# **CITY COUNCIL AGENDA REPORT**

**SUBJECT: URBAN MASTER PLAN SCREENING REQUESTS FOR UMP-06-09 FOR 2033 & 2037 ANAHEIM AVENUE IN THE MESA WEST RESIDENTIAL OWNERSHIP URBAN PLAN**

**UMP-06-09: RESIDENTIAL OWNERSHIP UNITS AT 2033/2037 ANAHEIM AVENUE  
IN MESA WEST RESIDENTIAL OWNERSHIP URBAN PLAN**

PROPOSED SITE PLAN

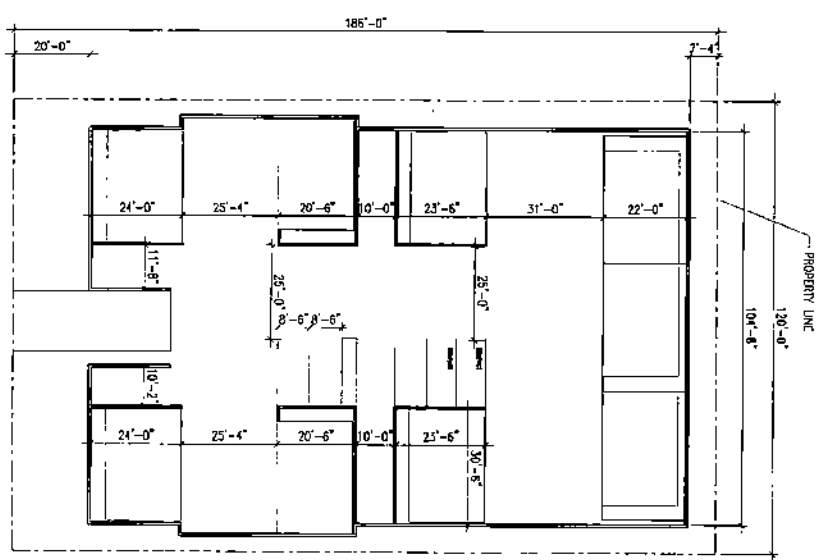
2. Proposal does not meet minimum 15-foot side setback requirements for three-story buildings. The Urban Plan requires a 15-foot side setback for three-story structures abutting a single-family residential property. In this case, the unit located in the northwestern portion of the project site is proposed at a 5-foot setback. Since the right side of the project site abuts single-family homes, a five-foot side setback is not considered sufficient to appropriately address shade-shadow, massing, and privacy impacts to neighboring single-family residences.

PROPOSED PARKING

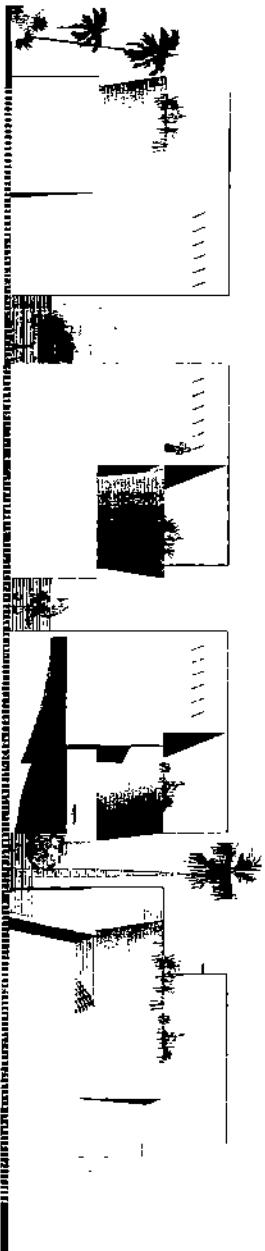
4. Parking supply and bedroom mixes may need to be adjusted. The proposal would need to be revised to comply with the City's parking ramp slope standards for underground parking structures. This would result in the redesign of the parking structure and loss of parking stalls. The bedroom mix of the proposed residences may need to be adjusted accordingly to account for the reduction in available parking area. In addition, the Planning Commission would need to approve the proposed compact parking stalls or require standard-sized stalls.

PROPOSED DESIGN FOR  
NINE UNITS COMPLEX

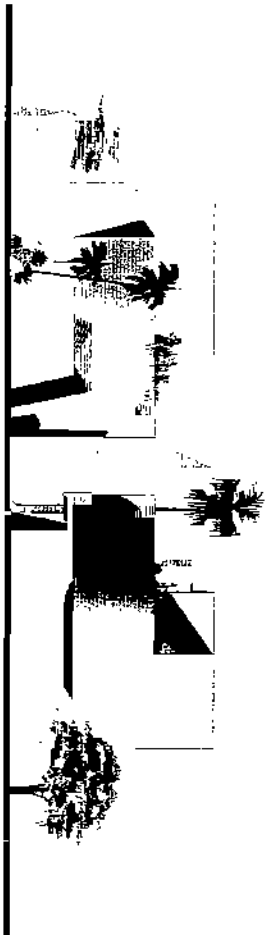
3. Architecture is considered too contemporary for residential neighborhood. While the Urban Plan promotes architectural innovation, staff considers the proposed architectural design is too modern for the neighborhood. The proposal also lacks articulation, varied building materials, and surface treatments. The proposed buildings would need to be modified to provide for appropriate building design, transitioning, and visual interest that would be compatible with the neighborhood.
